TECHNICAL EVALUATION REPORT

MASONRY WALL DESIGN

SURRY POWER STATION UNITS 1 AND 2

April 24, 1985

Typical Wall Modification - Boundary Conditions

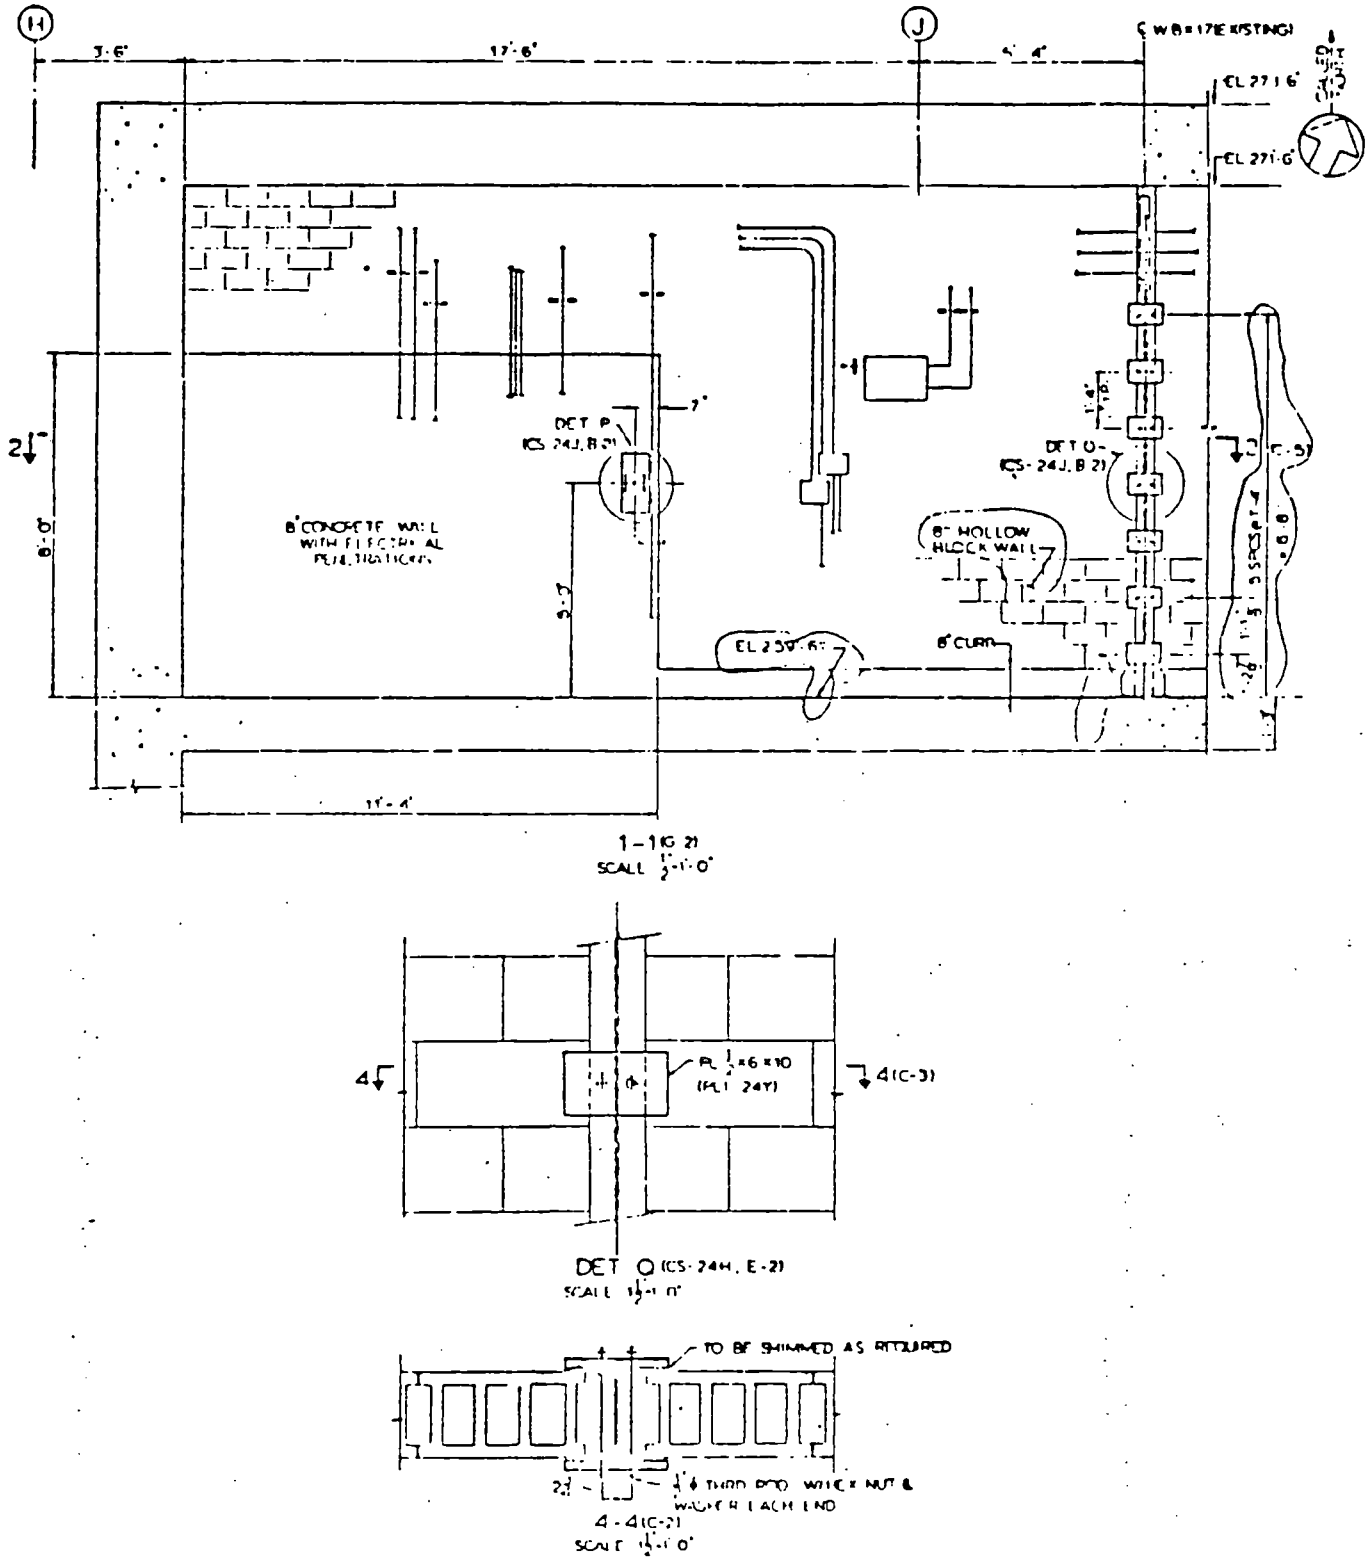
Provide sketches of the proposed wall modifications and indicate how these modifications will correct the wall deficiencies.

In response to this request, the Licensee provided sample sketches of the wall modifications. One set of sketches is an example of a wall which was modified by changing its boundary conditions and adding steel plates on both sides of an existing structural member to provide a pinned boundary. Another set of sketches is an example of a wall modification which reduced the unsupported span of the wall by adding vertical and horizontal members. Appendix B of this report presents the sketch of the typical wall modifications.

In the response to Question 5 (Section 3.1), the Licensee indicated that modifications were performed to change the boundary conditions and/or reduce the unsupported span. The Licensee also provided a sample modification with illustrative drawings. The Licensee's approach to wall modifications has been reviewed and considered satisfactory. (Appendix B provides sample modifications.)
